30 June 2020

D2020/32164[v3]

Warragamba Dam Raising 2017/7940 - Request to vary the proposal to take an action under Section 156A of the *Environment Protection and Biodiversity Conservation Act 1999*

FIGURE 1: Warragamba Dam Raising, Variation to EPBC Referral

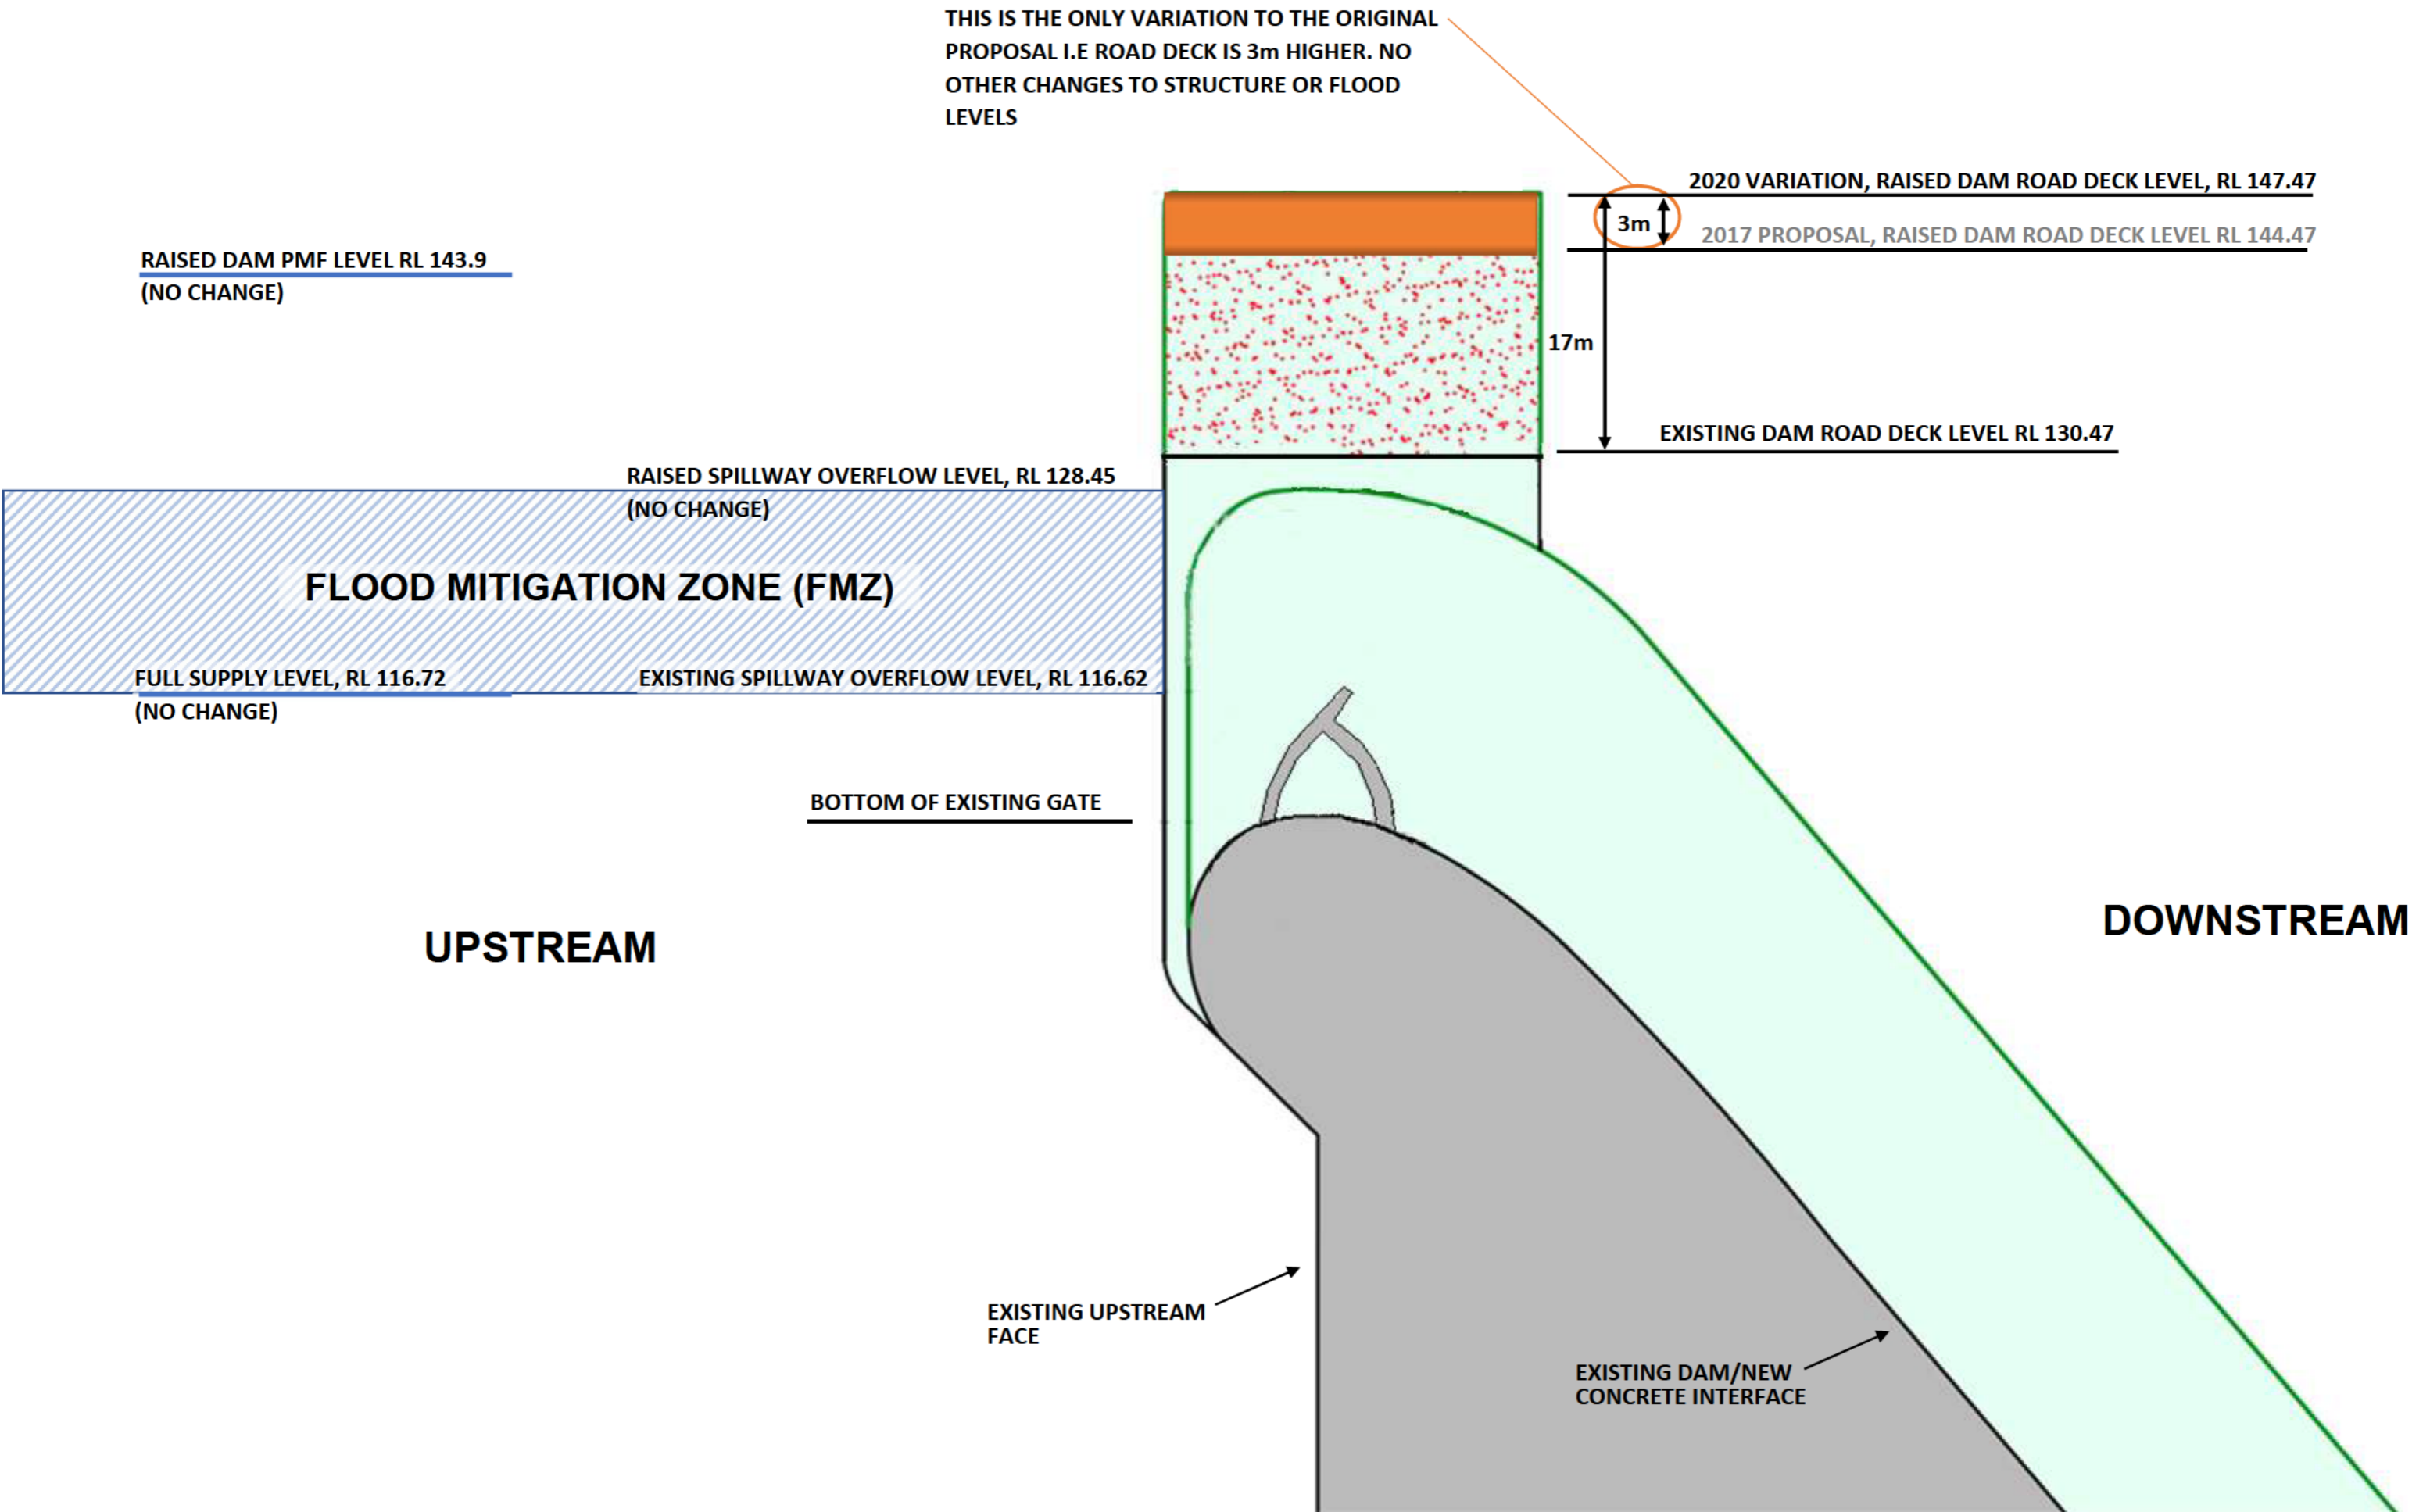
This variation allows the Project to include infrastructure for environmental flows and build into design, resilience of impacts to future climate change. The full supply level, spillway levels and flood impact levels remain unchanged from the original referral and proposed action. All upstream and downstream temporary inundation levels, durations and associated impacts remain unchanged from the original proposal. Table 1 below summarises the change in key levels applicable to the variation. Figure 1 attached, shows the consistency between the original proposal and this variation in terms of the storage levels in the dam (for the existing dam and proposed raised dam) but includes the updated height of the road level.

- the overall dam would be raised by 17 metres; but
- the spillway crest levels would be maintained at the levels proposed for the original 14 metre dam raising; so, there would be no change in the upstream inundation impacts or the downstream flood mitigation benefits.
